July 24<sup>th</sup>, 2025

The following is a written document to respond to the comments issued by the Design Review Board of the City of Miami Beach under file number **DRB25-1114**, in regards to the new construction to be located on 900 S Shore Dr (lot 9) Miami Beach, FL 33141. Architect's answers are in **bold**:

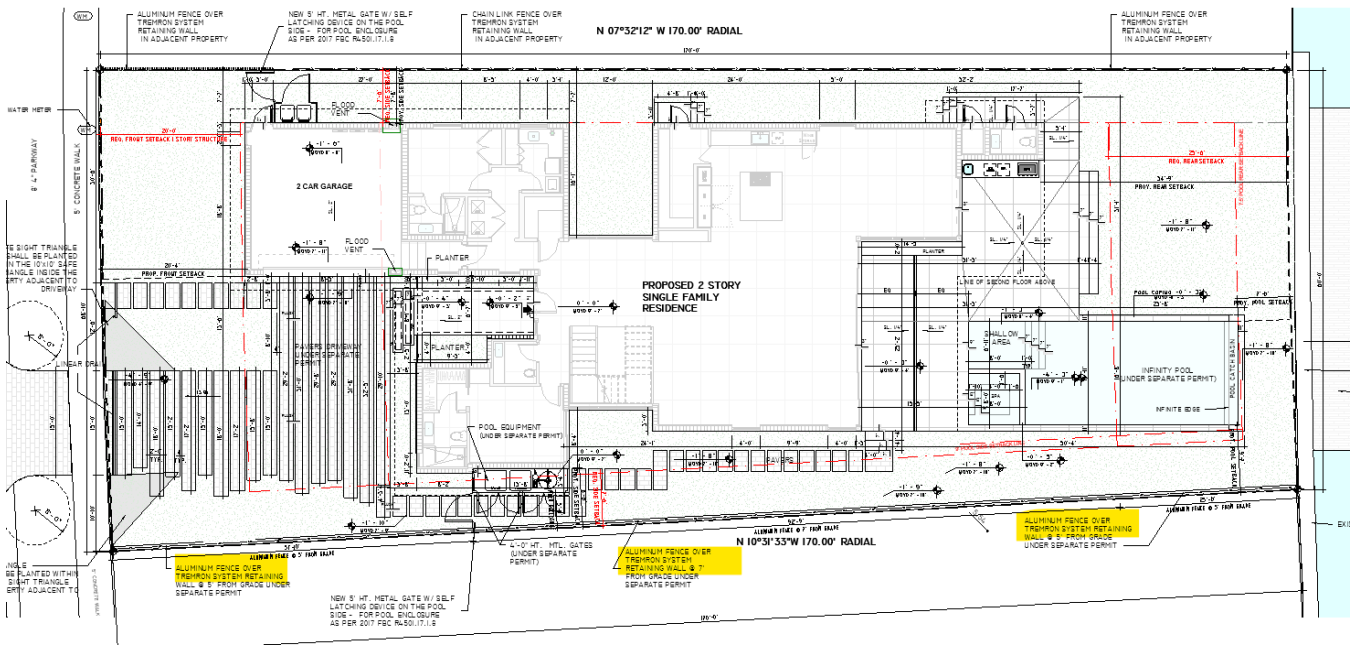
c. 7/22/25: 5 plans files were uploaded, this makes the review difficult, most of the files are less than 10 KB, please combine them. Files cannot exceed 25 KB, divide the plan set in 2 or more sets if required.

d. 7/22/25: some pages are organized out of page sequence, like pages A-302 and A-103. A-100-3, Site plan is not centered and has portion of other drawings/charts on it, revise. Organize the plans in the same checklist sequence 11a to 11q.

**R= Noted. The combined plans are not exceeding 25KB, therefore we've submitted the whole set merged.**

**R= Noted, we have fixed the set and are submitting the revised plans in the correct sequence.**

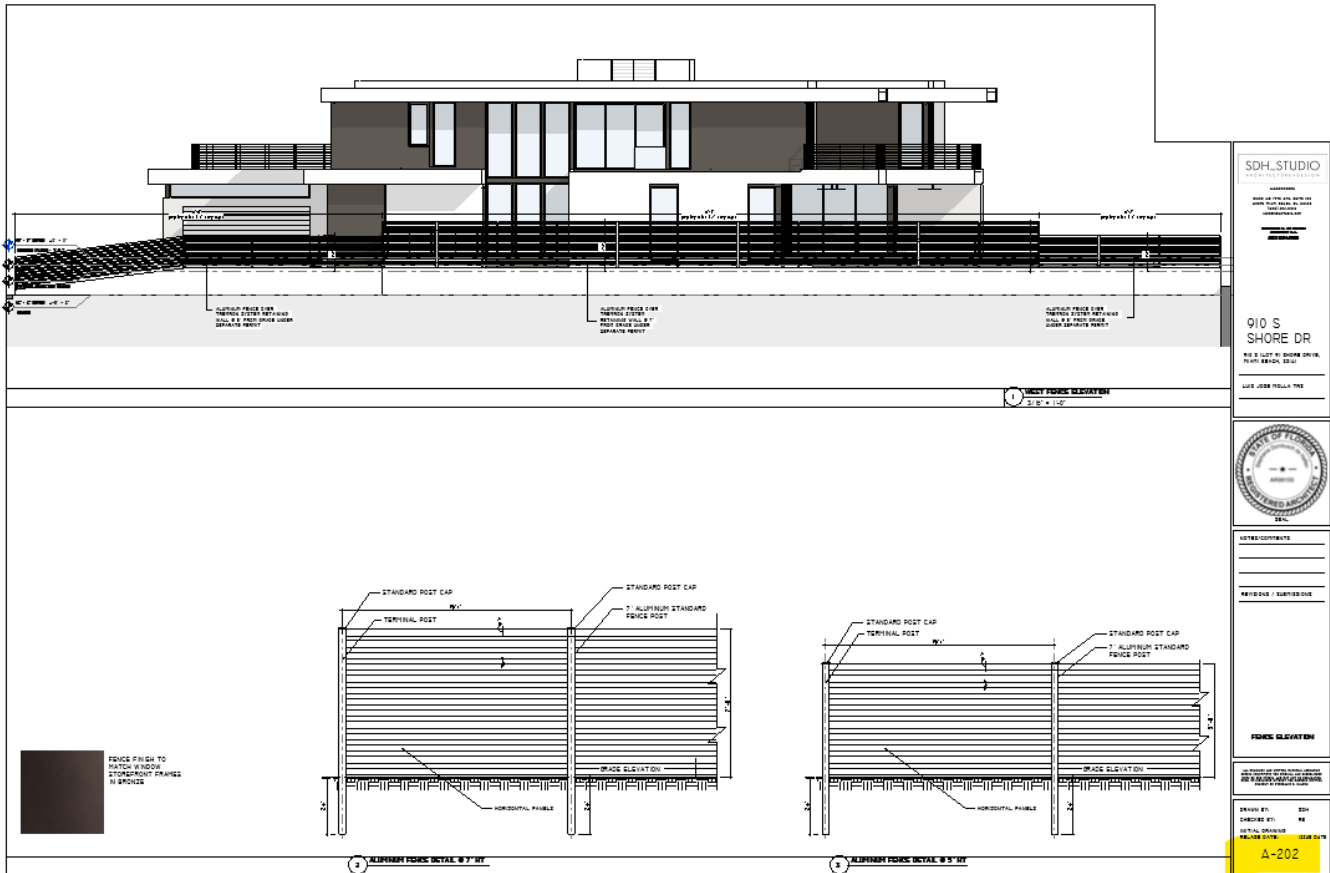
b. 7/22/25: missing elevations. In the event that a property has approval to be improved at future adjusted grade, the overall height of fences, walls and gates may be measured from future adjusted grade, provided that the portion of such fences, walls or gates above 4 feet in height consists of open pickets with a minimum spacing of 3 inches (see section 7.2.2.3.b.12.H.(1) Provide future adjusted grade, future crown of the road and based floor elevation values on elevations/sections // Elevations, Site plan/first floor plan: Retaining walls/fences: Demonstrate compliance with Section 7.2.2.3.b.12.H. Provide height and setbacks if applicable for the existing/proposed walls on the required rear, side, side facing the street and front yard on the site plan. indicate where the new and existing walls stop/start. Provide

separate detailed elevations for the proposed walls/fences/gates, provide height dimensions from grade or future adjusted grade, materials etc.,

**R= Noted, please refer to new sheet A-202 for the fence elevation and details.**

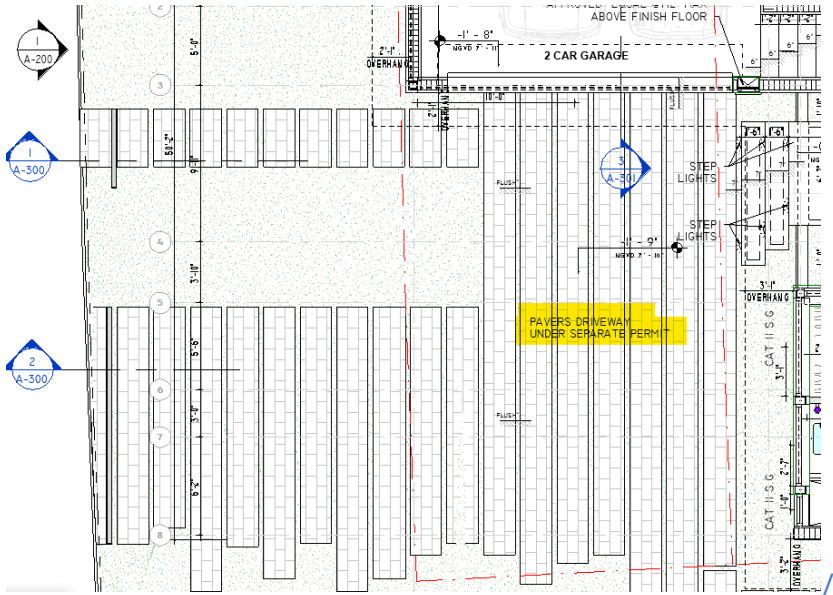
c. 7/22/25: Insufficient: Concrete driveway shown on site plan. All allowable exterior walkways and driveways within the front and street side yards shall consist of pavers set in sand or other semi-pervious material. The use of concrete, asphalt or similar material within the required front or street side yards shall be prohibited. Provide the pervious paver finish of the driveway in the site plan.

**R= Please see the revised driveway and walkway materiality in sheets A-100.3 and A-101.**
